CITY OF VANCOUVER
POLICY REPORT
DEVELOPMENT AND BUILDING

TO: Vancouver City Council
FROM: Director of Planning
SUBJECT: CD-1 Rezoning - 5429-5439 Willow Street

Project Name: WILLOW STREET TOWNHOUSES
Site Plan: 1/8" SITE PLAN

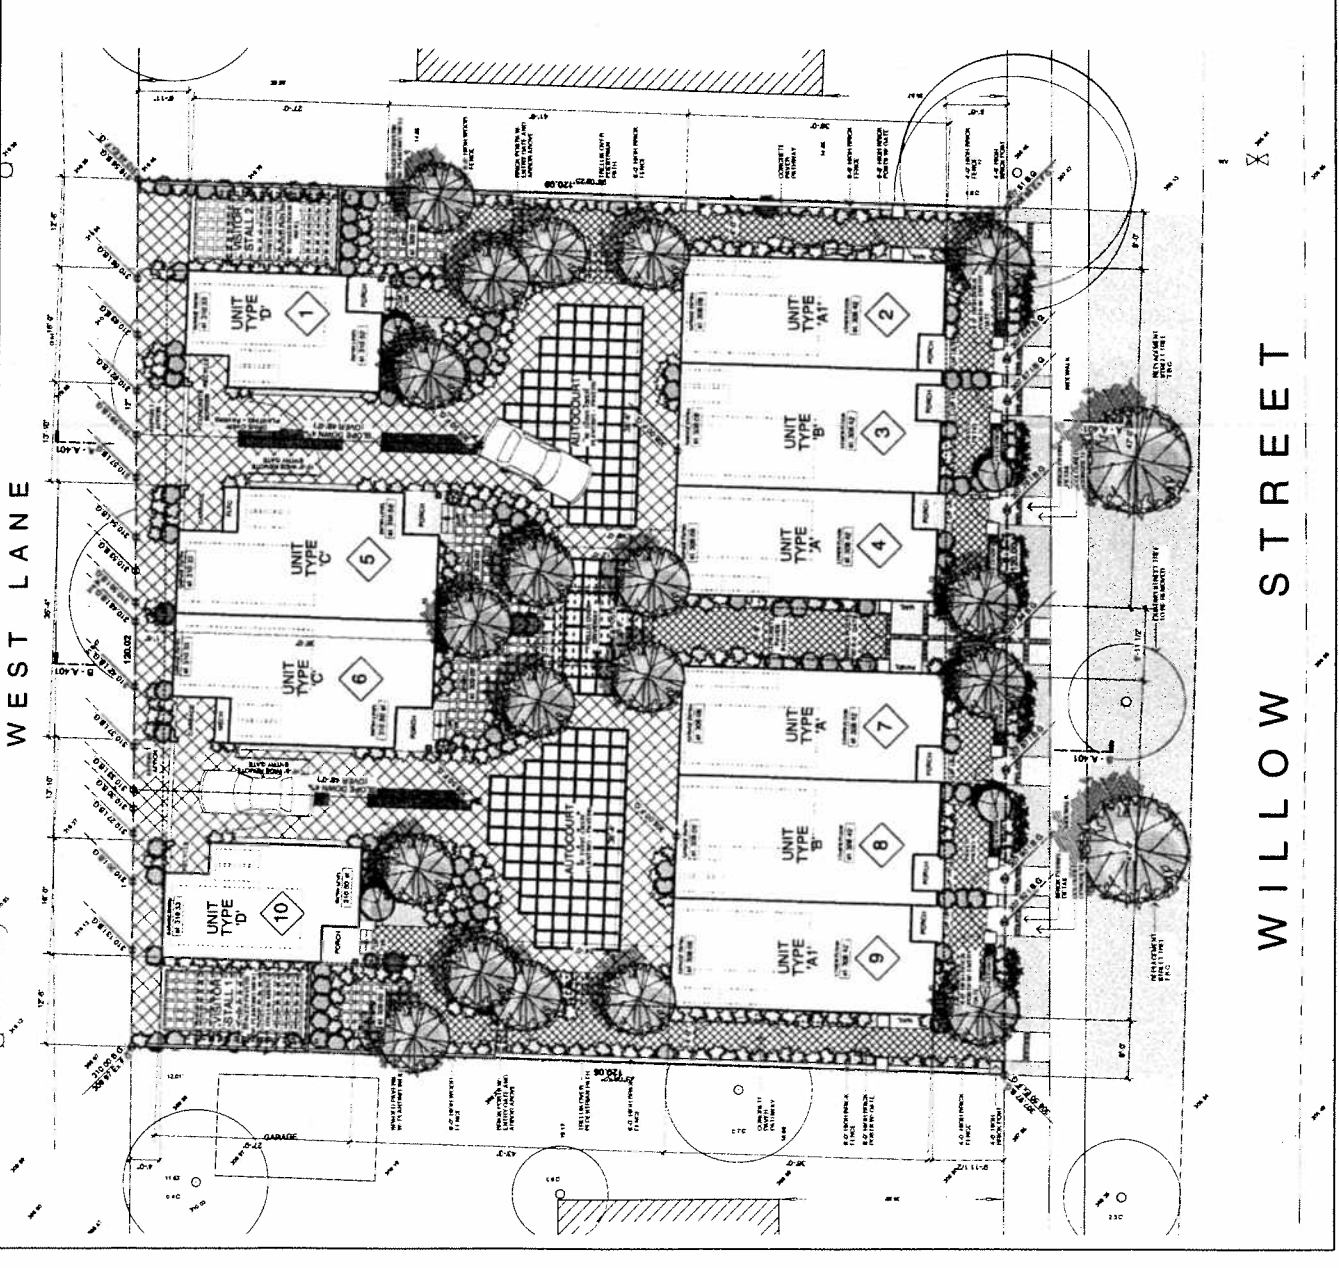
- (vi) Design development to the parking, removing all unenclosed surface parking, which includes the two visitor parking spaces at grade, and providing more private outdoor amenity space and landscaping.

Note to Applicant: At grade parking is supported provided that parking spaces are enclosed within a dwelling unit and there is only one parking space per dwelling unit. Parking at grade exceeding more than one parking space per dwelling unit is not supported.

Note to Applicant: The detail design of these spaces differs as illustrated on the Landscape Plan and Site Plan. Adjust the layout of the private outdoor spaces to accommodate a secure common green space to connect with the lane. Replace the visitor parking spaces with green landscaped areas for common use. Refer to Design comment above.

1/8" ELEVATIONS
 EAST + SOUTH

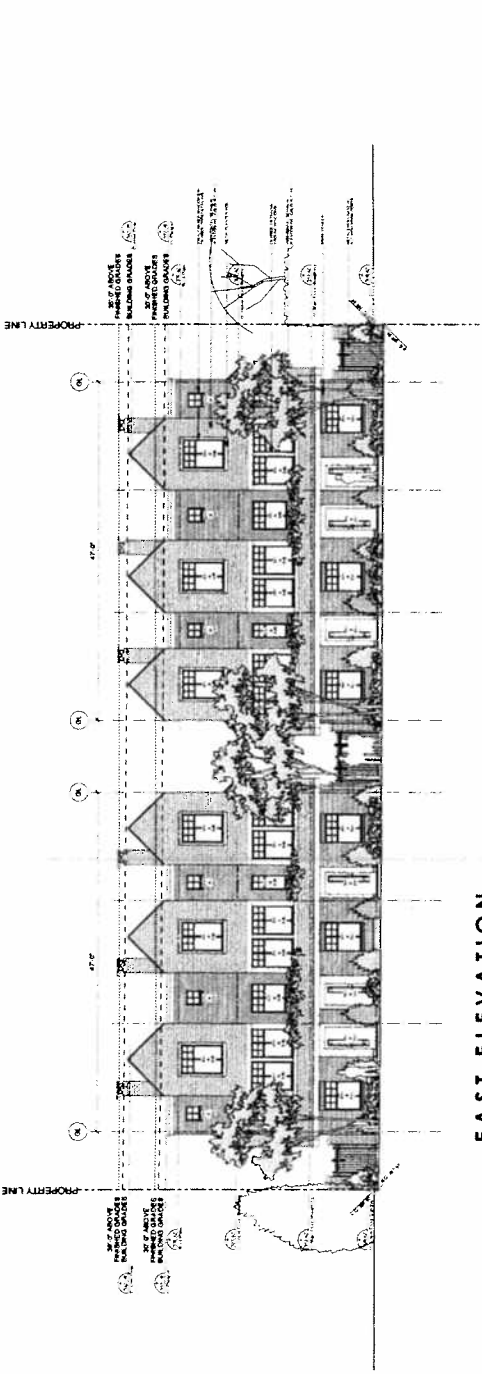
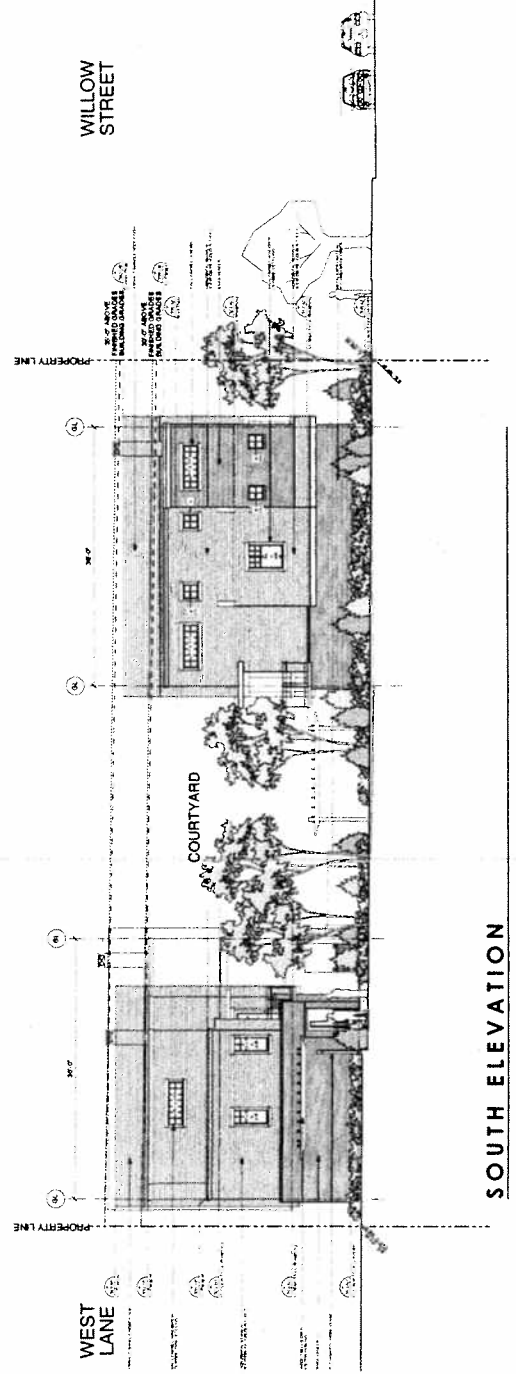
- (i) Design development to the building materiality, increasing substantially the amount of brick masonry on the building exterior.

Note to Applicant: The amount of brick masonry as indicated on the drawings is considerably less than what was earlier proposed. The applicant is advised that brick should be the predominate material, covering approximately two-thirds of the exterior walls. All building elevations should have a similar and consistent treatment, with equal amounts of brick on all building faces. Consider cladding the gable ends with brick as originally proposed.

- (iii) Design development to the building massing, removing the continuous planter box, street elevation.

Note to Applicant: Consider an alternative horizontal element(s) that is lighter and less boxy in appearance, while preserving the individual identity and vertical separation of the townhouse form.
